**M/s.IMAIGAL TRUST**  
*(Implementing Agency - Kongu Coir Cluster, Erode)*

**Tender No:** SFURTI-II/TN-ERODE/BLDG-001/2019-20 dated 13.01.2020

**Tender for Construction of Industrial Work Shed Buildings and Amenities for  
the Common Facility Center of Kongu Coir Cluster**

**CORRIGENDUM-1 dated 01.02.2020**

DRAWN	YASIN	07.11.19	TITLE
CHKD.	Dr.L.SJ	07.11.19	<b>CROSS SECTION DETAILS</b>
APPD.			<b>PROPOSED FACTORY BUILDING</b>
SIZE - A2	SCALE - 1:125	DWG NO : 02	SHT.1 OF 1

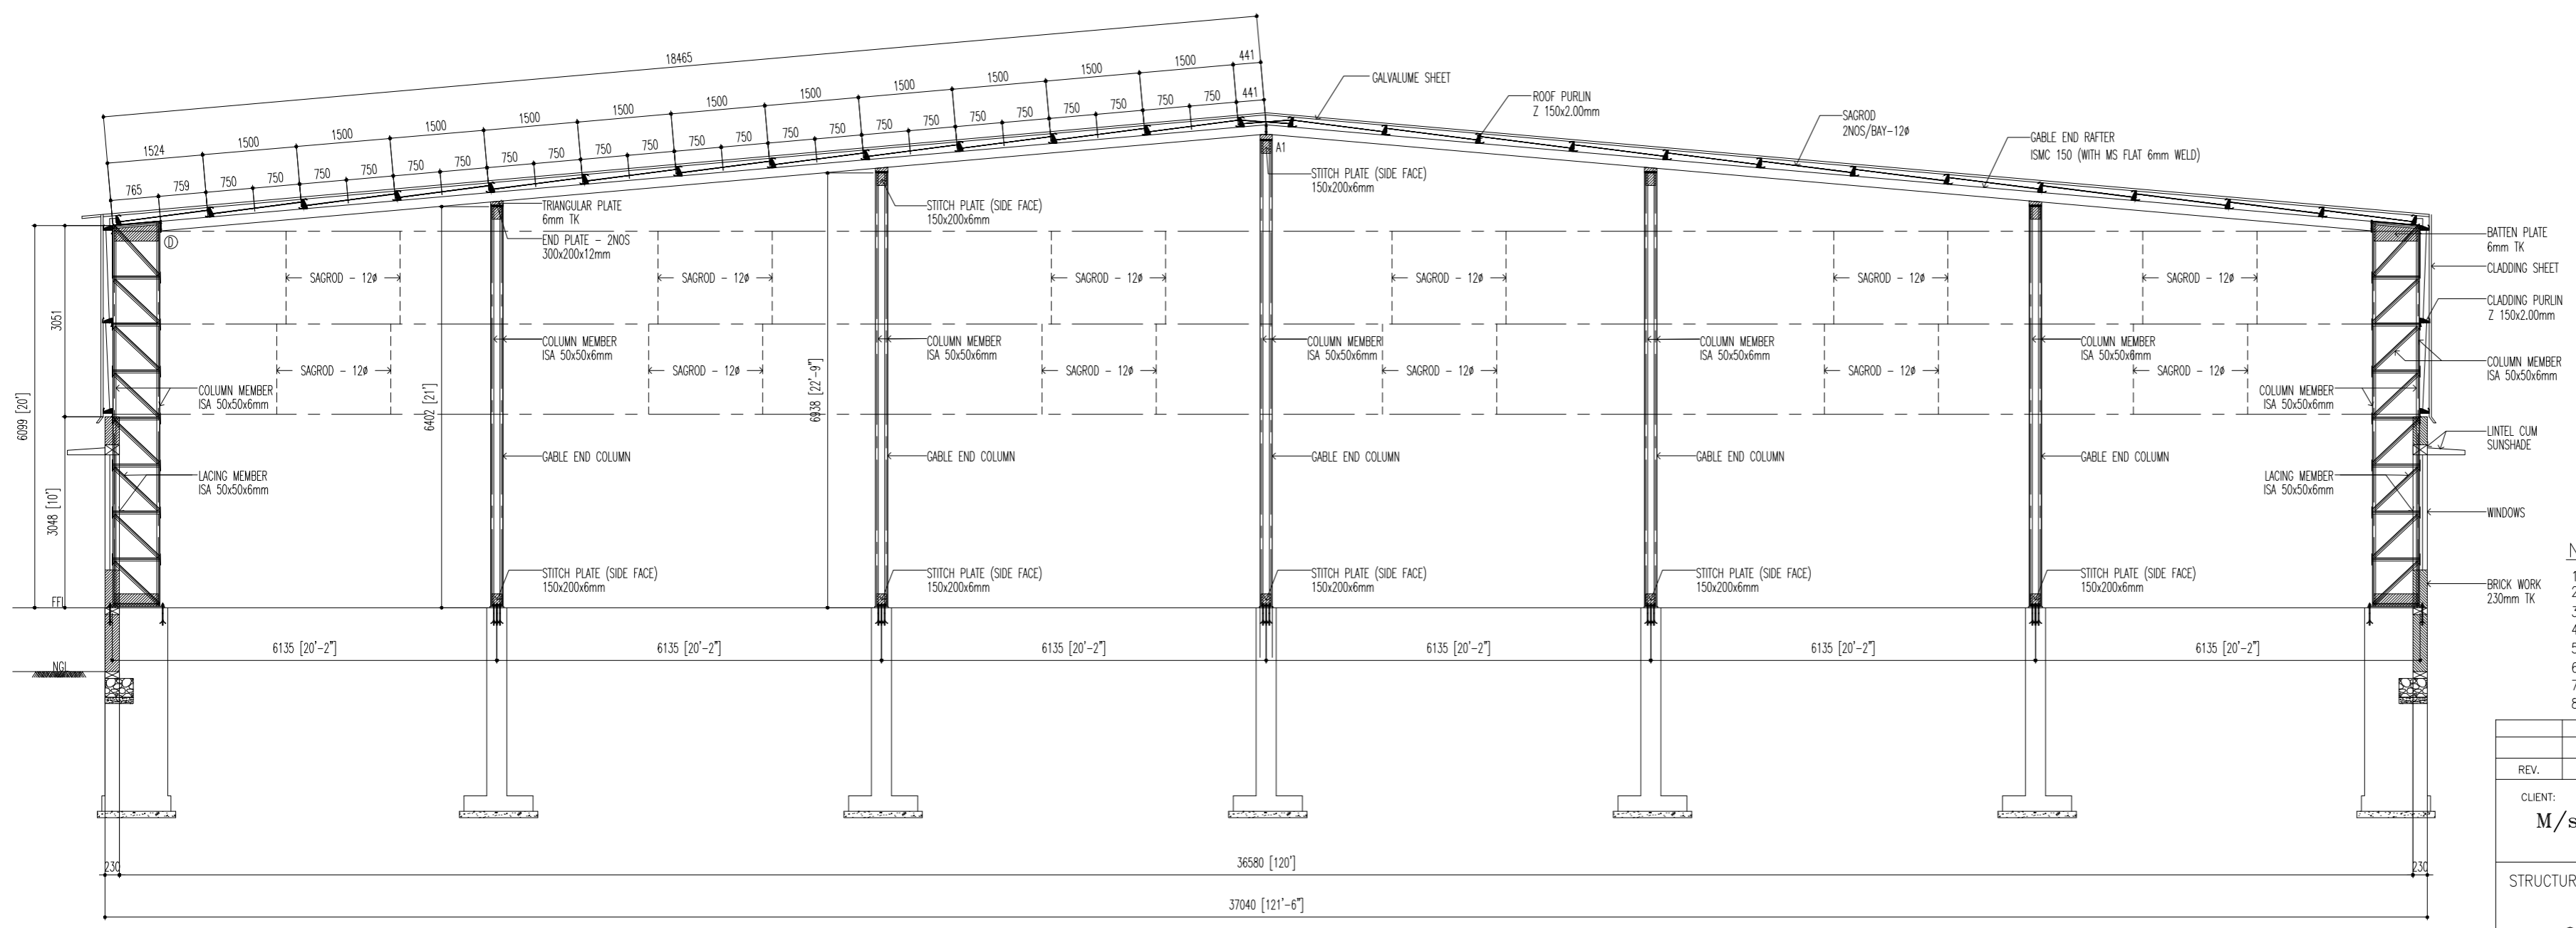
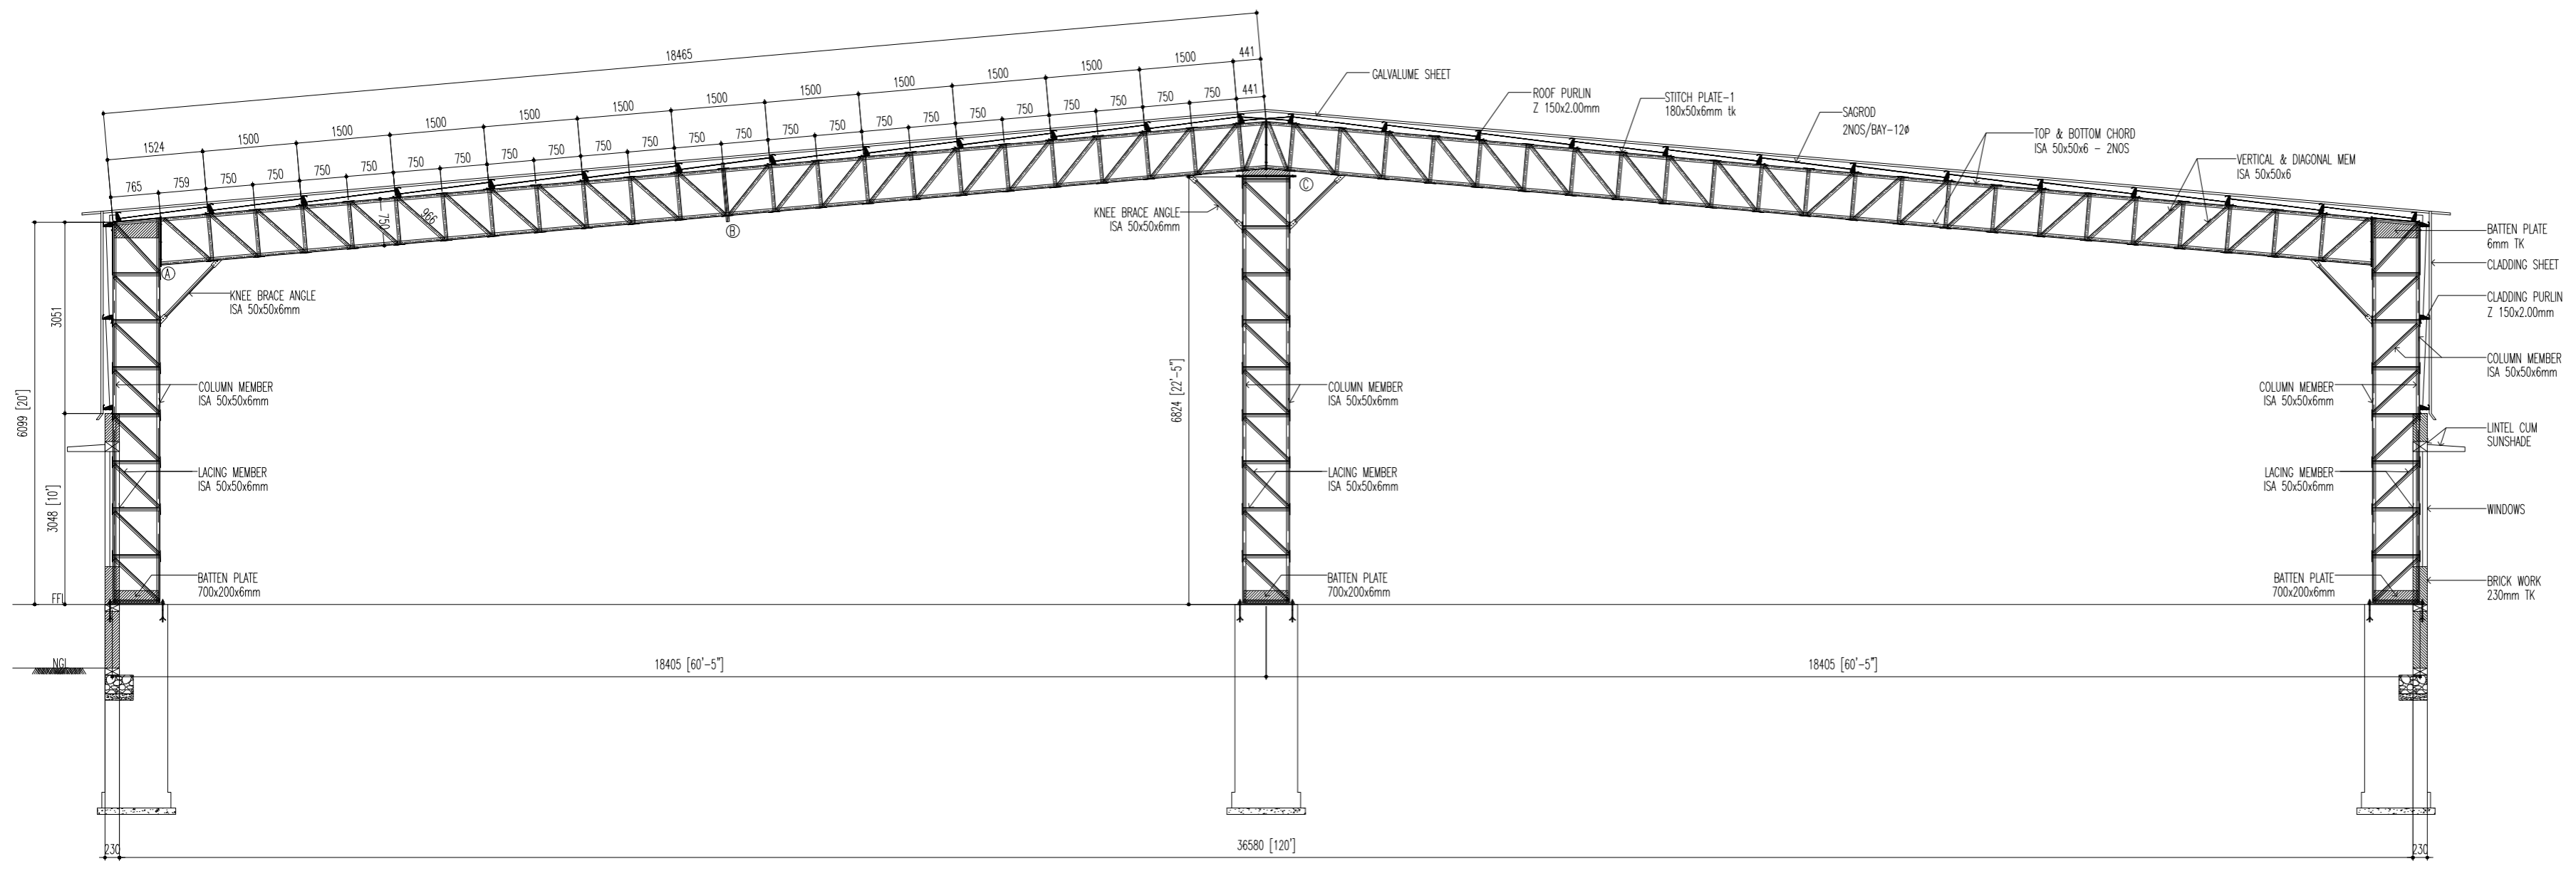
<b>S.No</b>	<b>Page No</b>	<b>Clause No.</b>	<b>Existing Clause</b>	<b>Revised Clause</b>
1.	12	Annexure – I	<b>(To Add)</b>	Drawing for the structural steel truss and steel column are included in Annexure I of tender document

2.	Page No.12 Annexure – I	Clear detailed drawing for the structural steel truss and steel column not given.	Drawing for the structural steel truss and steel column are included in the Tender document (Refer Corrigendum-1)
